NORTH ANNA POWER STATION

Section 3.2 Power Distribution Limits

VOLUME 8

Improved Technical Specifications

Figure B 3.2.18-1 (page 1 of 1)
K(Z) - Normalized $E_0(Z)$ as a Function of Core Height

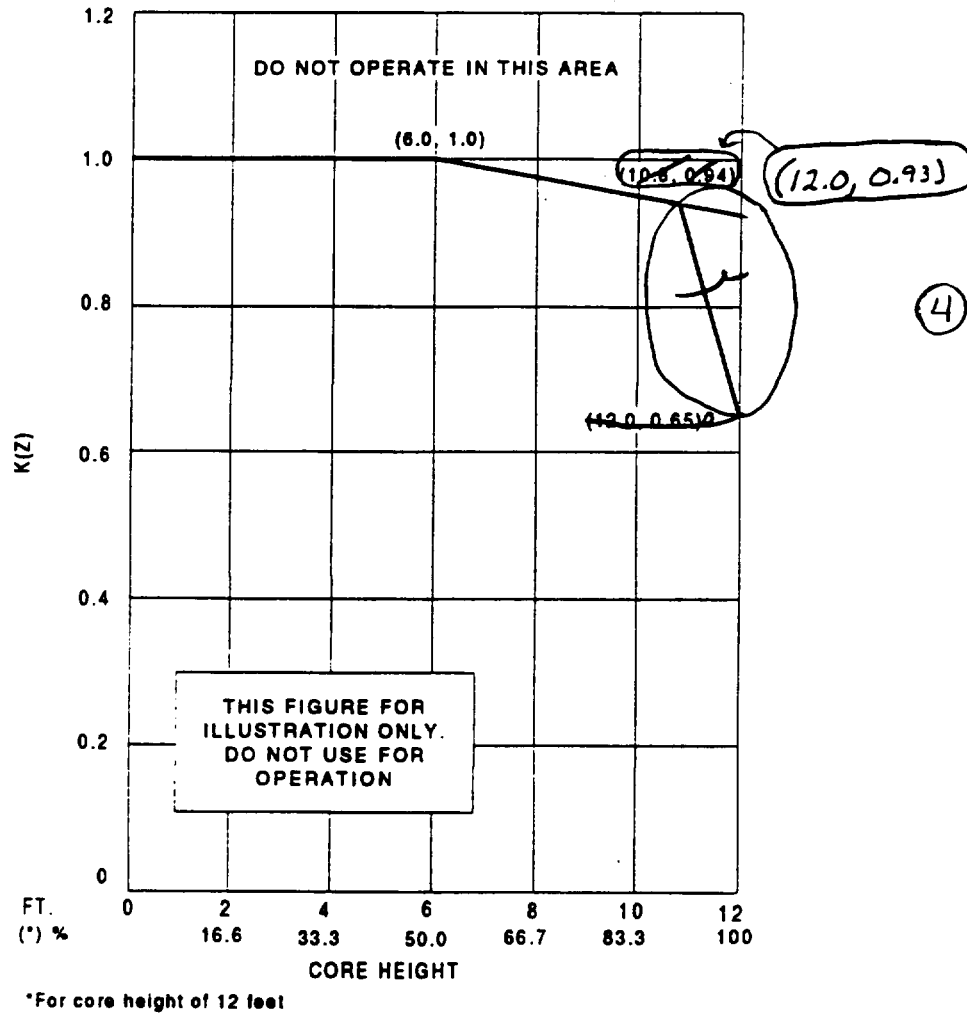
For this facility, the actual values of CFQ and K(Z) are given in the COLR; however, CFQ is normally a number on the order of 2.32 and K(Z) is a function that looks like the one provided in Figure B 3.2.13-1.

1. The Bases are revised to reflect the Relaxed Power Distribution Control (RPDC) methodology and changes made to the ITS to implement that methodology.

Figure B 3.2.38-1 (page 1 of 1)
AXIAL FLUX DIFFERENCE Acceptable Operation Limits
as a Function of RATED THERMAL POWER

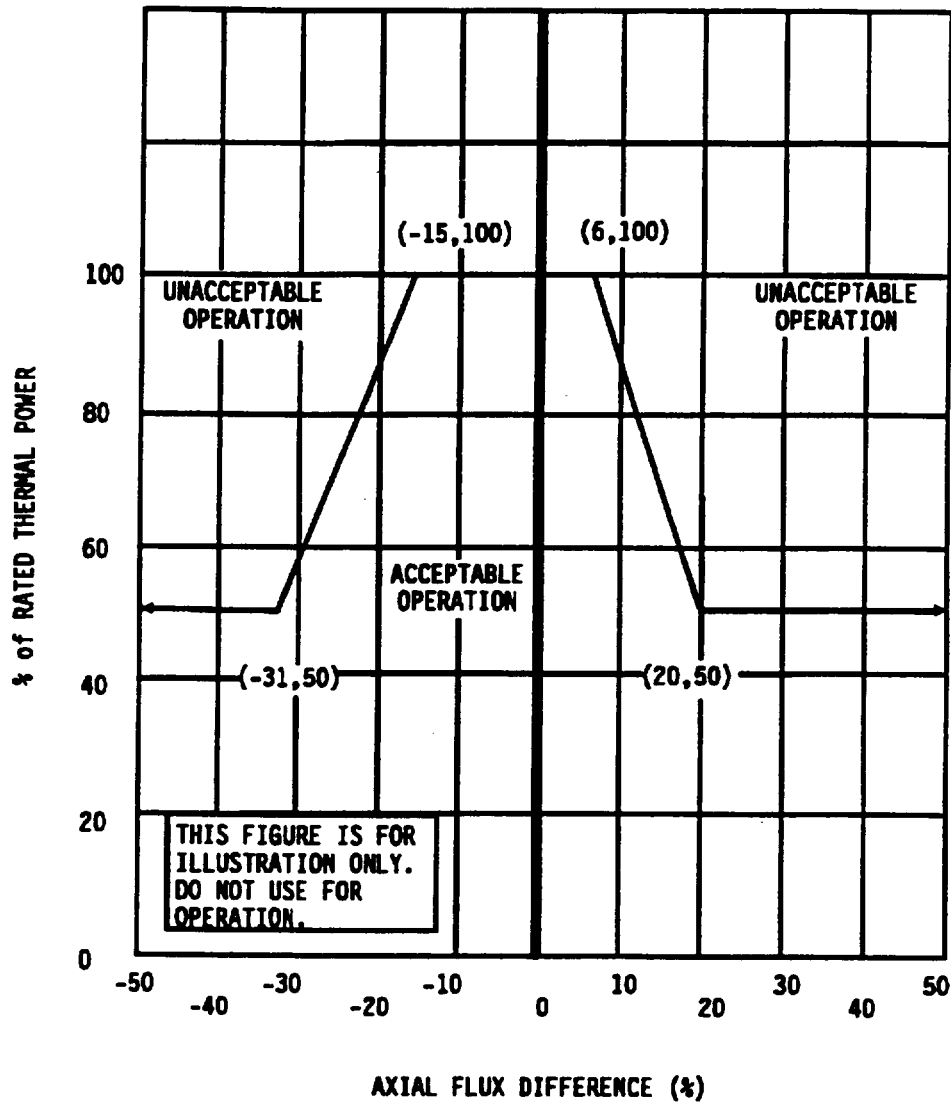
RPDC The AFD limits are provided in the COLR. Figure B 3.2.38-1 shows typical RAOC AFD limits. The AFD limits for RAOC do not depend on the target flux difference. However, the target flux difference may be used to minimize changes in the axial power distribution.

1. The Bases of ITS 3.2.3B, AFD (RAOC Methodology) is revised to reflect the Company Relaxed Power Distribution Control (RPDC) methodology and associated FQ Surveillance Technical Specifications approved by the NRC in VEP-NE-1-A, March, 1986. Terminology, descriptions of analytical methods, and references are changed as needed.
